AMENDMENT #1

Please note the following changes for Schedule A – Irrigation Drawing

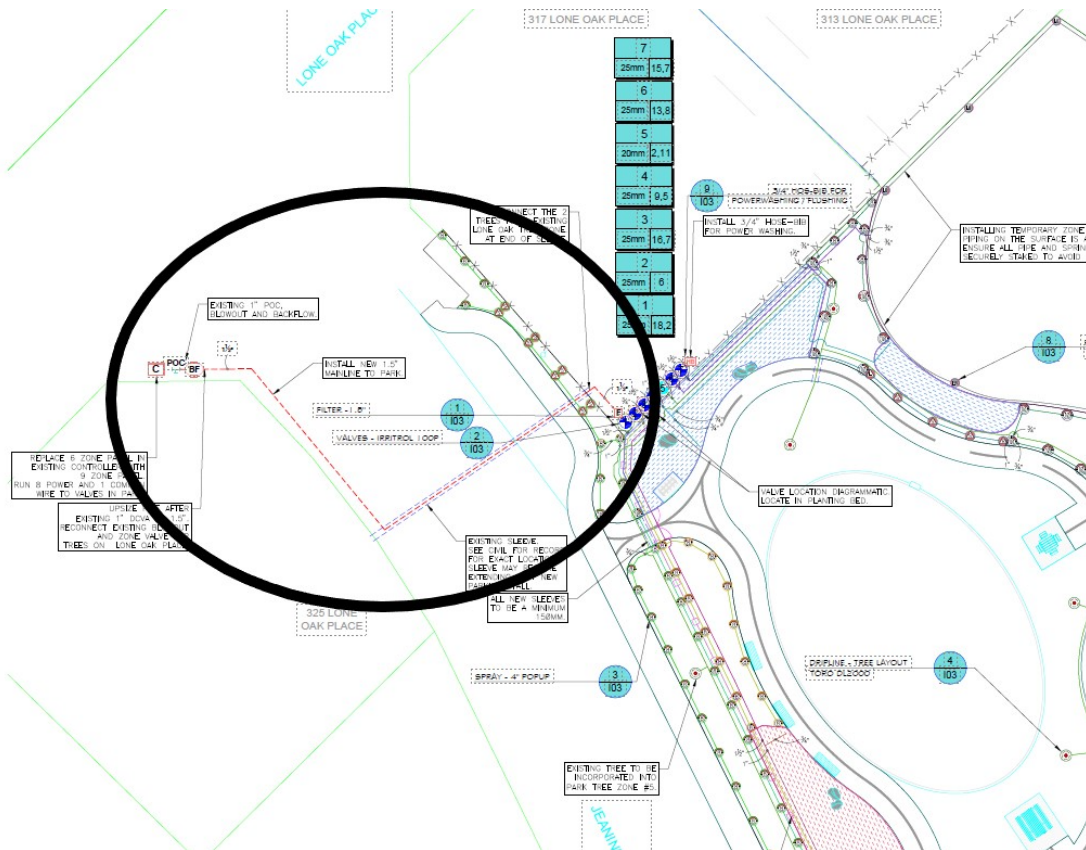
Please be advised that the following will be completed prior to RFP award. Please do not include the below in your pricing:

1. Replace 6 zone panel in existing controller with 9 zone panel and run 8 power and 1 common wire to new valve locations in park.
2. Upsize pipe after existing 1 inch DCVA to 1.5 inch. Reconnect existing blowout and zone valve for trees on Lone Oak Pl.
3. Install new 1.5 inch main line to park through existing sleeve. See civil for record of exact location of sleeve. Sleeve will require extending past new sidewalk.
4. Disconnect the two trees from existing Lone Oak tree zone at end of sleeve.
